**Re: March 4, 2015 Power Outage Report (*Power Outage/Incident Advisory 2015-H-062*)**

Further to your letter of April 21, 2015 regarding the above referenced report, the following are Hydro's responses to the Board's questions.

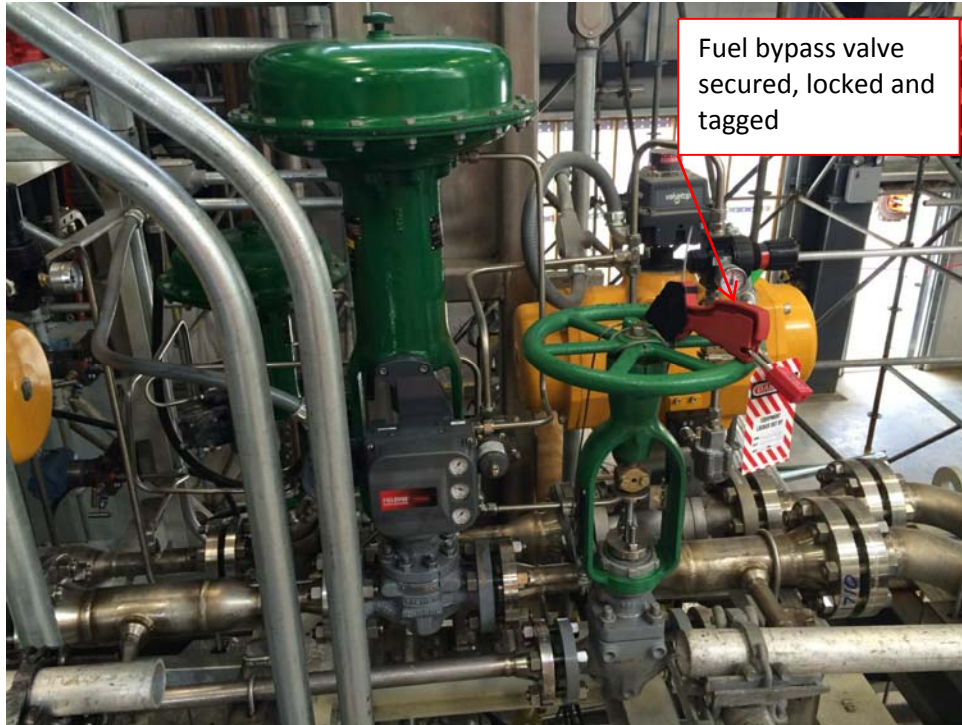
- Q6. *At Section 4.2, Primary Cause 2, a further cause of the outage is identified as being the incorrect flow rate of fuel from a fuel valve on the Holyrood Combustion Turbine.***
- a. Provide pictures of the valve in question prior to any lock out modifications effected.***
  - b. Provide pictures of the valve in question following lock out modifications effected.***
  - c. Provide a clear indication either through photographs or diagrams as to the location of the valve on the unit and its accessibility for inadvertent contact.***

- a. Please see the photo below showing the fuel valve prior to any lock out modifications being affected.

- b. Please see the photo below showing the valve following lock out modification. The valve has been secured, locked and tagged. While it is not visible in the photograph, the valve has also been marked to indicate the valve set position and a pre-start up verification of the valve position has been instituted.

- c. Please see the photos below showing the location of the valve. The valve is not located on the turbine itself, it is located on the fuel, oil, and water injection skid, on an elevated platform within the plant. As can be seen in the photos, scaffolding is in place to facilitate access to the area.

**Figure 1 – Avalon Peninsula Voltages and Reactive Power vs Gross Avalon Demand<sup>6</sup>**

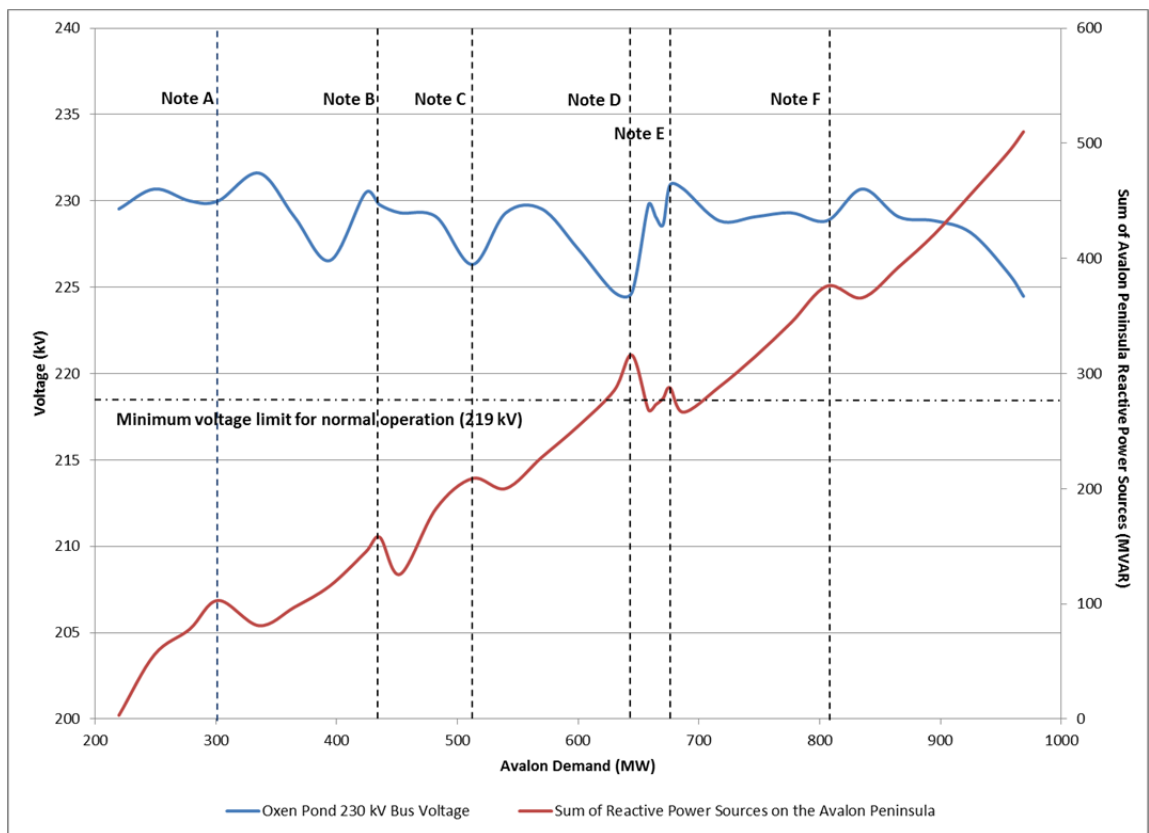
**Q11. *Provide a graph(s) showing the relationship between the generation on the Avalon, the load on the Avalon, the load on the in-feed from Bay d'Espoir and the voltages on the Avalon.***

A11. The relationship between the generation, the load, the in-feed from Bay d'Espoir, and voltages on the Avalon Peninsula are demonstrated in the figures provided below. These figures were developed based on load flow analysis performed using Version 32 of PSS<sup>®</sup>E software from Siemens PTI.

As indicated, voltages are held above the minimum thresholds over the operating range. This is accomplished by increasing reactive support on the Avalon Peninsula through the operation of capacitor banks and by bringing additional generators online, as illustrated by the red line in the plot below.

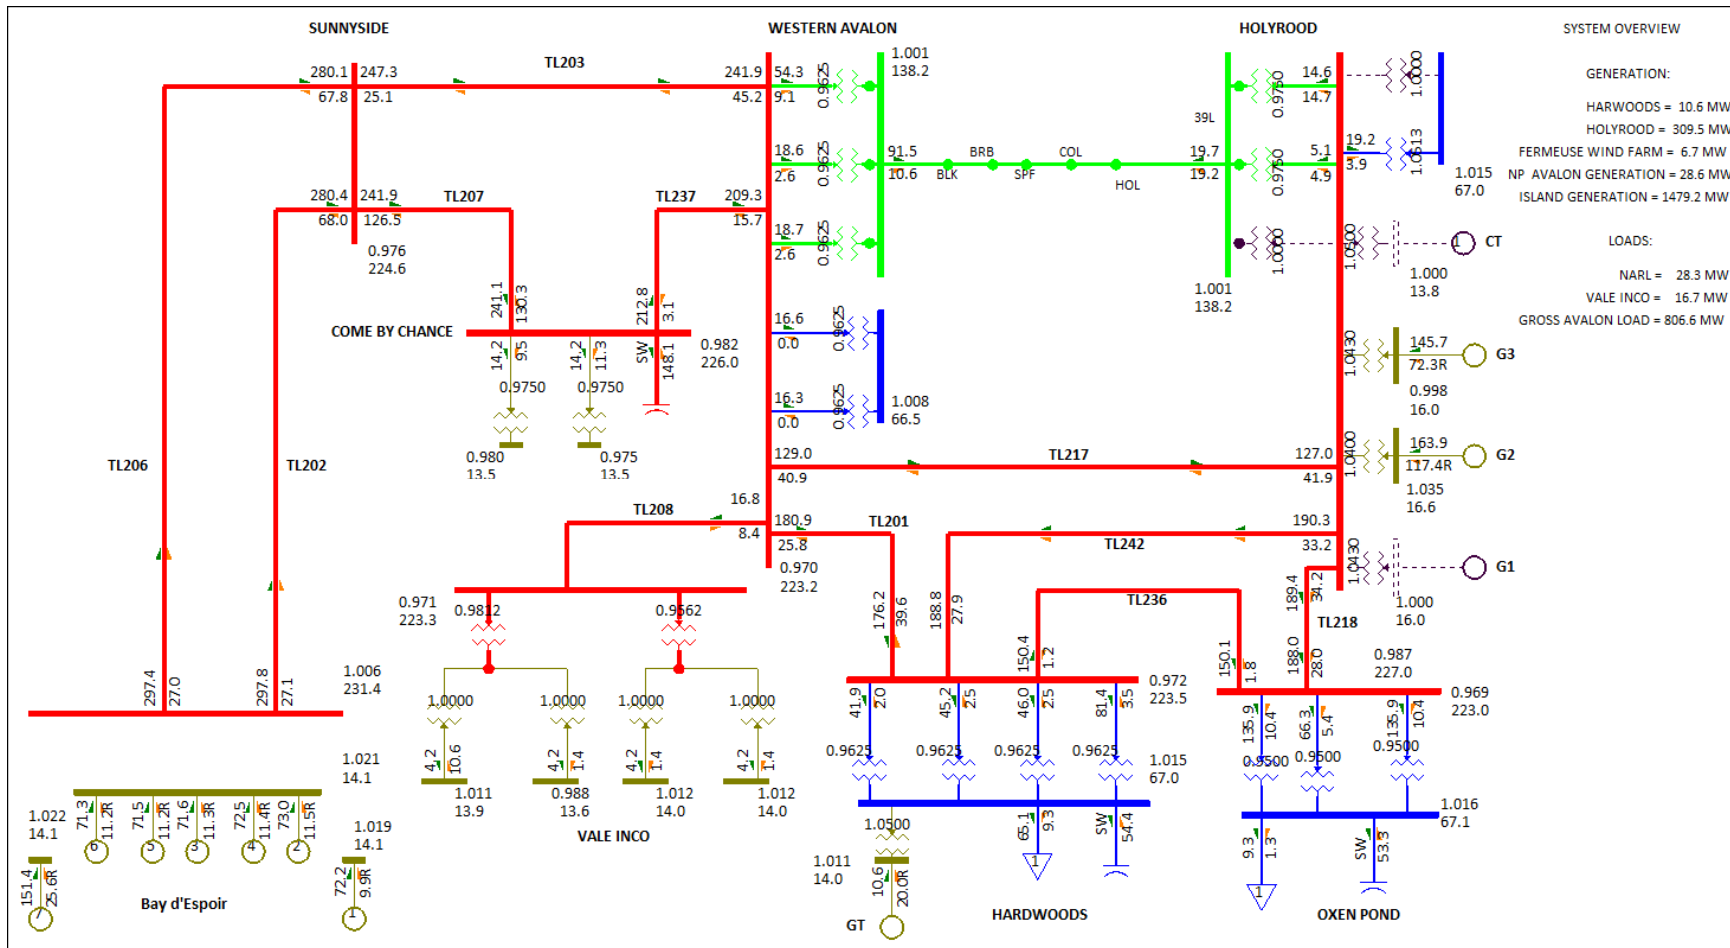
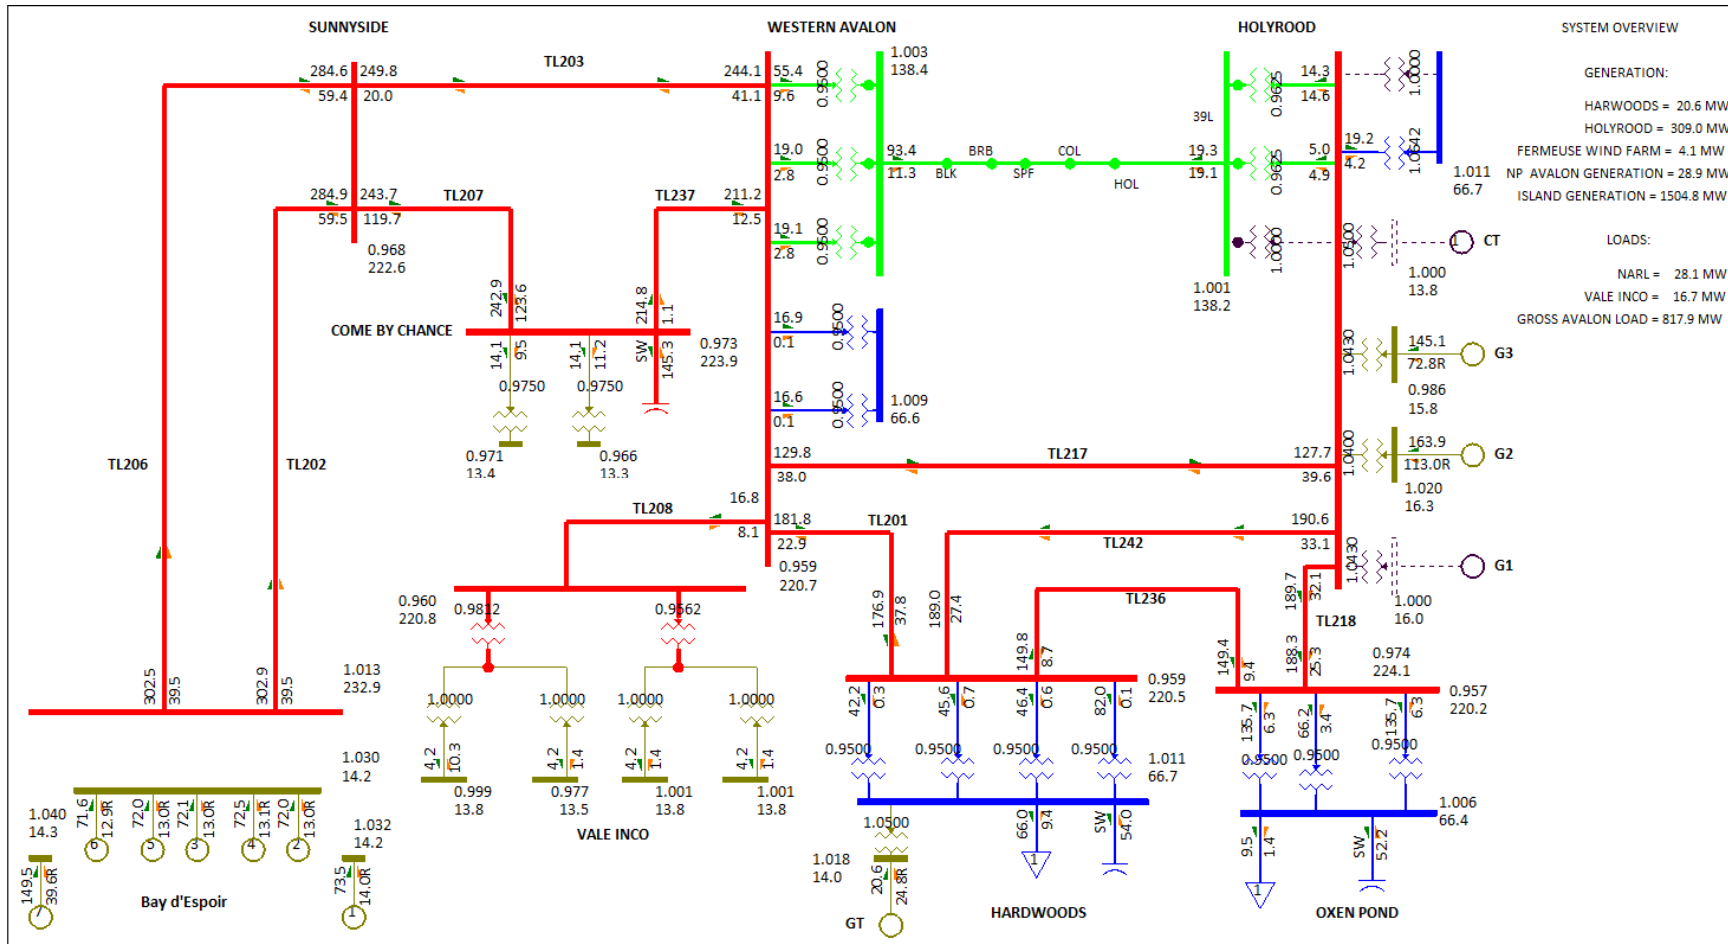
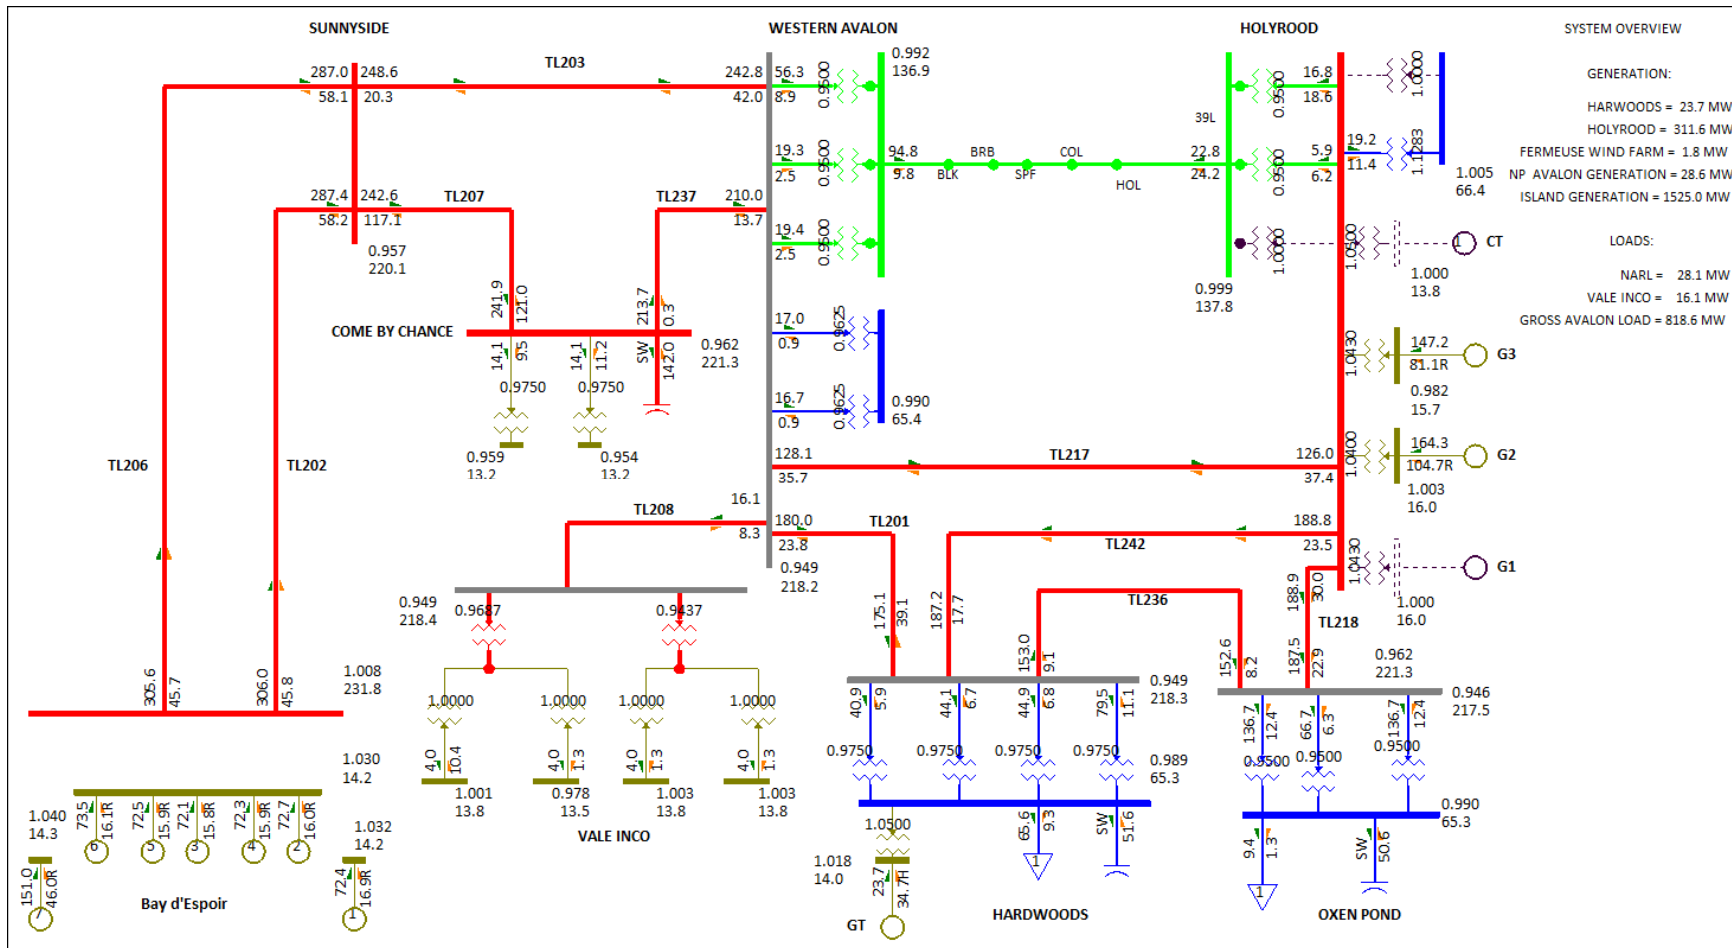
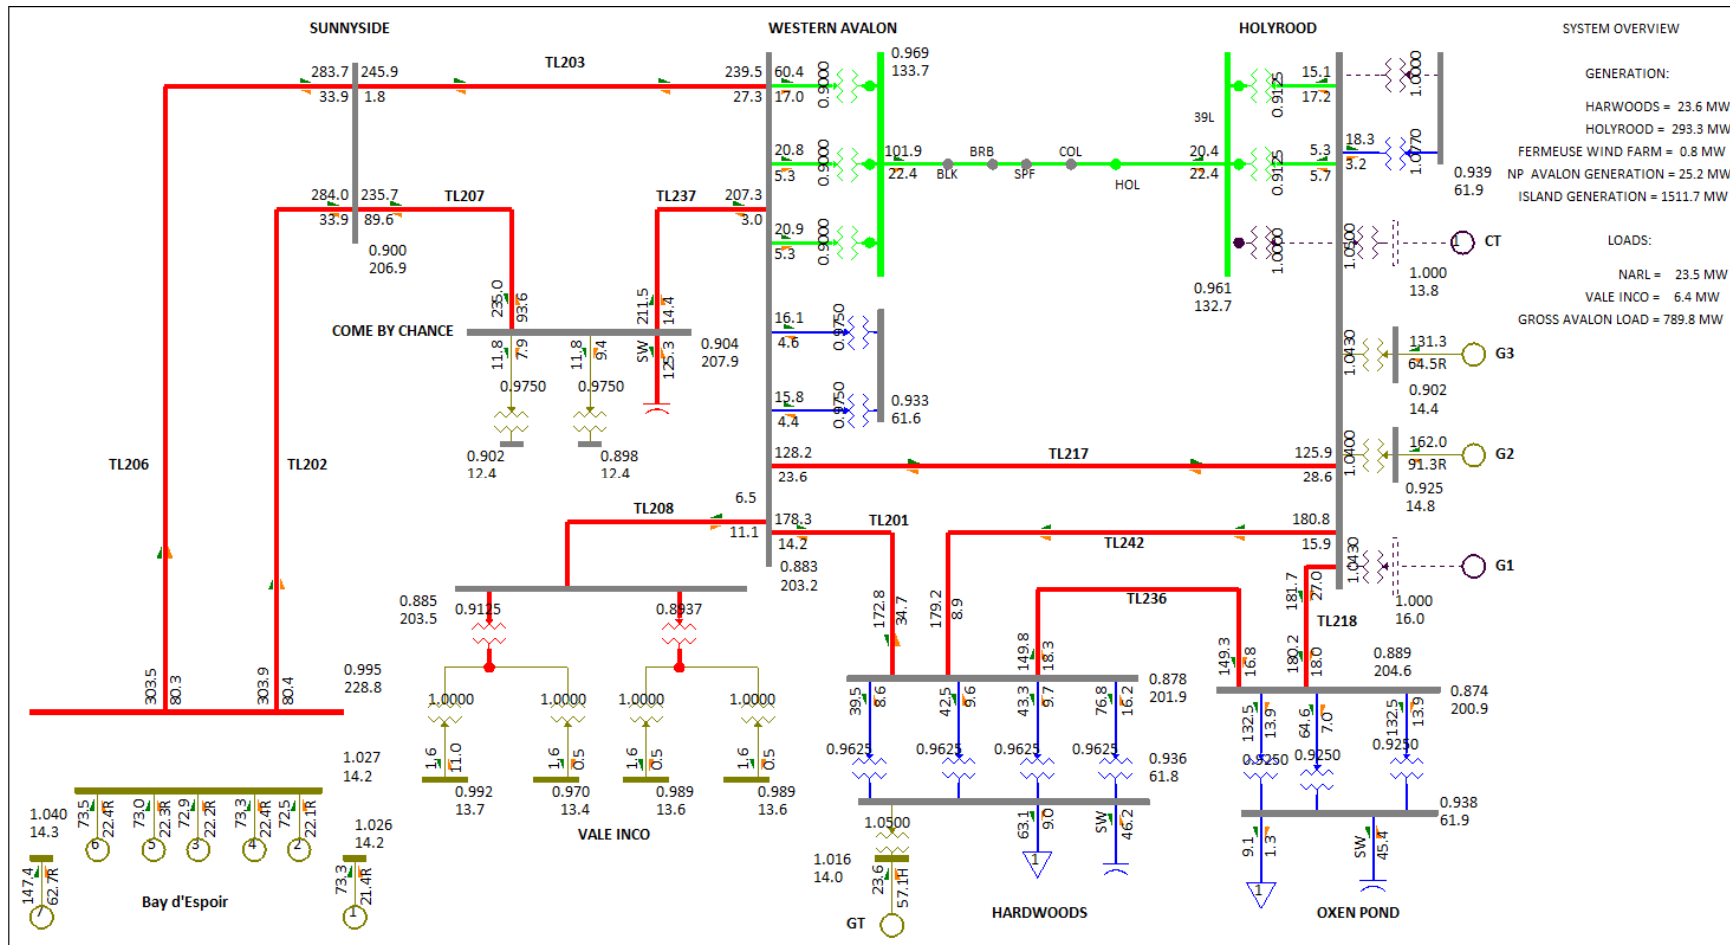
**Q14. *Provide load flow study results for March 4, 2015 in diagrammatic form in 15 minute intervals commencing at 06:15 until 07:14 for the Island Interconnected System.***

A14. Please see Appendix 3 for load flow plots for the interval commencing at 06:15 until 07:14 for the Island Interconnected System. The plots illustrate system bus voltages, real power flows (provided above the line) and reactive power flows (provided below the line) on the Avalon Peninsula.

If the voltage of a bus drops below 95% of nominal value, the colour is changed to grey. For example, the Oxen Pond 66 kV bus is coloured blue at 07:00 and grey at 07:14. As per the events described in the Power Outage Report, the plots contained in the appendix detail the system conditions over the specified timeframe. As indicated, system voltages are acceptable

prior to 07:00. At 07:00, low voltage conditions are noted at 230 kV buses at Western Avalon Terminal Station, Voisey's Bay Nickel (Vale Inco) Terminal Station, Hardwoods Terminal Station, and Oxen Pond Terminal Station. Extensive low voltage conditions are noted at 07:14.
